P98-002 - I-80 Industrial/ Lot 4

- REQUEST:
- A. **Environmental Determination: Negative Declaration**
 - B. **Mitigation Monitoring Plan;**
 - C. **Plan Review to develop two one-story warehouse buildings totaling 83,750 square feet on 4.95 vacant acres in the Light Industrial (M-1SR) zone in the North Sacramento Community Plan area (D2).**

LOCATION: Raley Blvd. and Diesel and Bell Avenues
238-0220-009
North Sacramento/ Raley Industrial Park
Grant Joint Union / Robla School Districts
Council District 2

Exhibit 1B
Site Plan

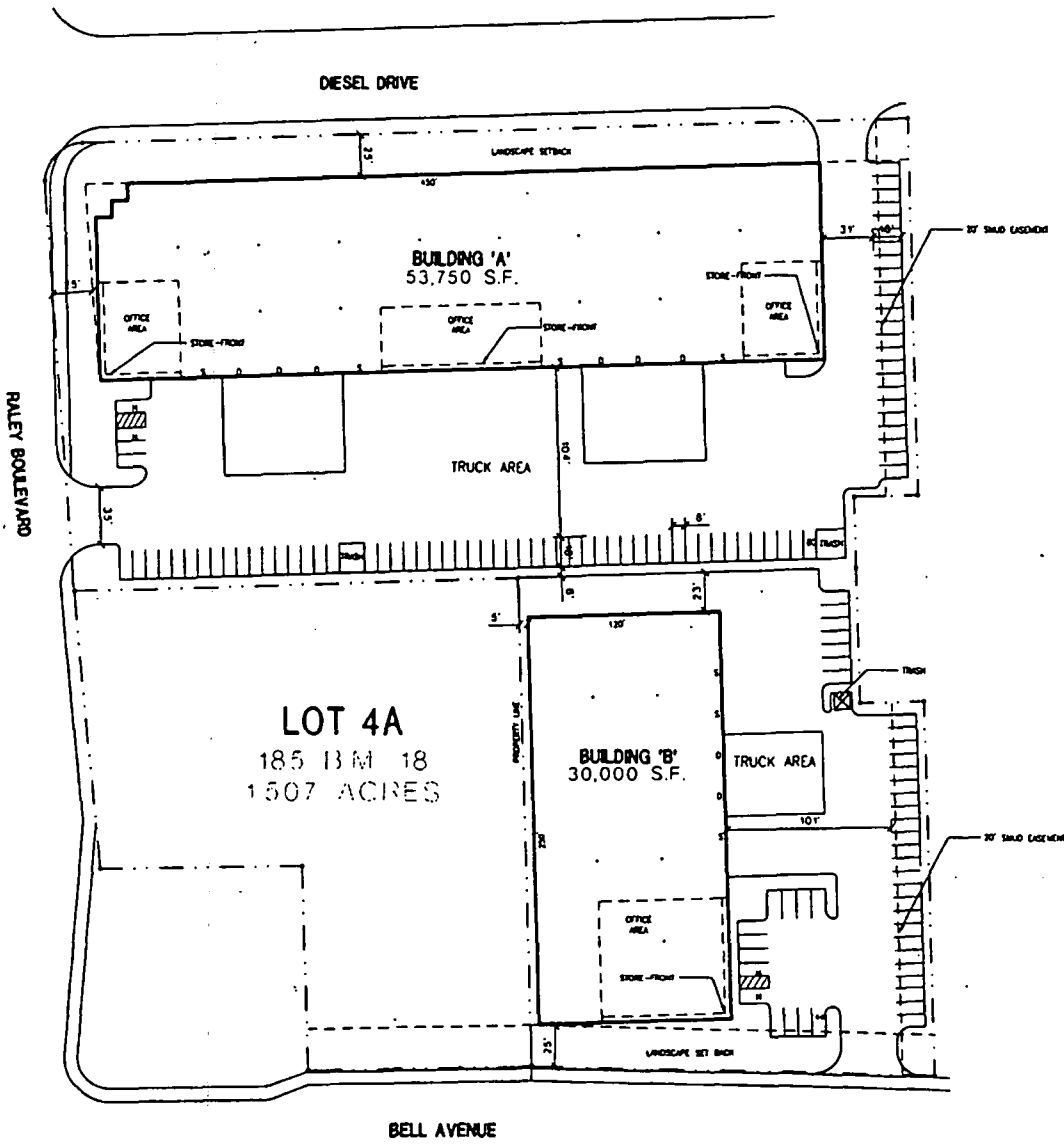
- A fire flow analysis would need to be done.
- The setback of Building B should be a minimum of 20 feet from the rear property line.
- A KNOX Box would need to be placed on each building.
- There needs to be additional hydrants (every 300 feet around the building) cross tied and looped within the development .

- Show the existing and proposed improvements on Raley Blvd. and Bell Ave. Include center lines, right-of-way lines, curb, gutter, sidewalk and driveway cuts.

- The minimum throat depth for driveways on Raley Blvd. and Bell Ave. is 60 feet. Throat distance is that distance a vehicle must travel before being able to turn either right or left. This results in the loss of eight parking spaces- four from each entrance.

- Driveways shall be to City Standards and to the satisfaction of the Department of Public Works.
- Owner must comply with A.D.A. requirements.
- The southern most trash enclosure must be relocated further north in order to provide the necessary maneuvering space for vehicles (20 feet).

- There is a 25 foot ingress/egress easement which runs adjacent to the northern side of the East property line. Twelve and a half feet of this easement is on the subject site and 12.5 feet is on the adjoining site. Please show this easement and the necessary area of the adjoining site on the revised site plan. The purpose of this easement is to provide access to Lot A of the I-80 Industrial Park. This easement can not be built on, parked over or obstructed in any way.

- There is a 20 foot overhead line easement adjacent to the southern section of the East property line. Ten feet of this easement is on the subject site and 10 feet is on the adjacent site. This easement must be shown and the necessary area of the adjoining site on the revised site plan.

- D5. The Parking lot shade ordinance would need to be followed.
- D6. A fire flow analysis would need to be done prior to obtaining a building permit.
- D7. The setback of Building B should be a minimum of 20 feet from the rear property line.

- D10. On the revised site plan, show the existing and proposed improvements on Raley Blvd. and Bell Ave. Include center lines, right-of-way lines, curb, gutter, sidewalk and driveway cuts.

- D11. The minimum throat depth for driveways on Raley Blvd. and Bell Ave. is 60 feet.
- D12. Driveways shall be to City Standards and to the satisfaction of the Department of Public Works.

- D13. Owner must comply with A.D.A. requirements.
- D14. The southern most trash enclosure must be relocated further north in order to provide the necessary maneuvering space for vehicles (20

- D15. On a revised site plan, show the 25 foot ingress/egress easement which runs adjacent to the northern side of the East property line. Twelve and a half feet of this easement is on the subject site and 12.5 feet is on the adjoining site. The purpose of this easement is to provide access to Lot A of the I-80 Industrial Park. This easement can not be built on, parked over or obstructed in any way.

- D16. There is a 20 foot overhead line easement adjacent to the southern section of the East property line. Ten feet of this easement is on the subject site and 10 feet is on the adjacent site. This easement must be shown and the necessary area of the adjoining site on the revised site plan.

Exhibit 1D
Landscape Plan

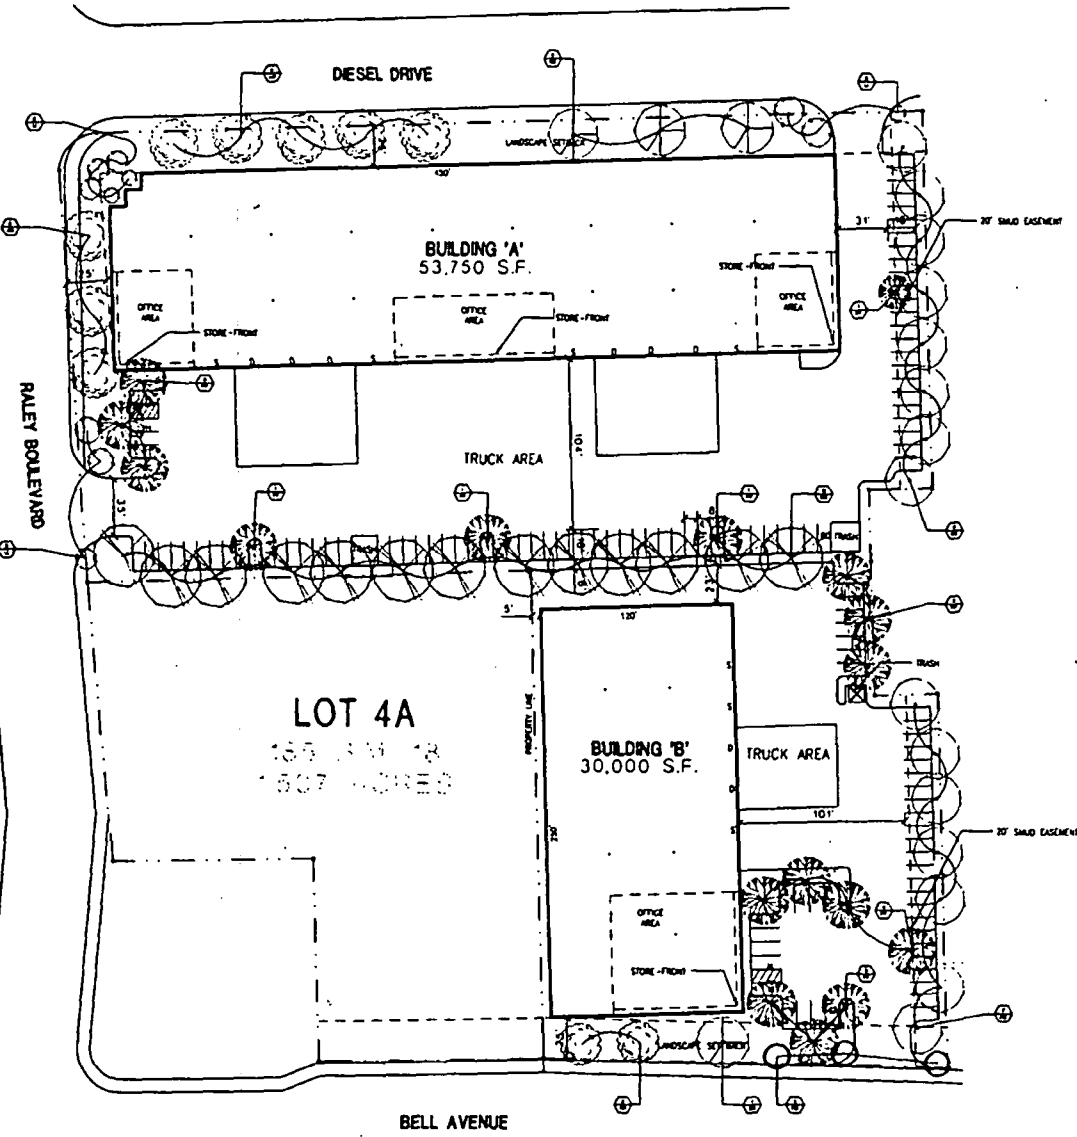
The proposed project would provide landscaping in the 25 foot setback areas as well as meeting the 50% shading requirement of the parking lots.

The Parking lot shade ordinance would need to be followed.
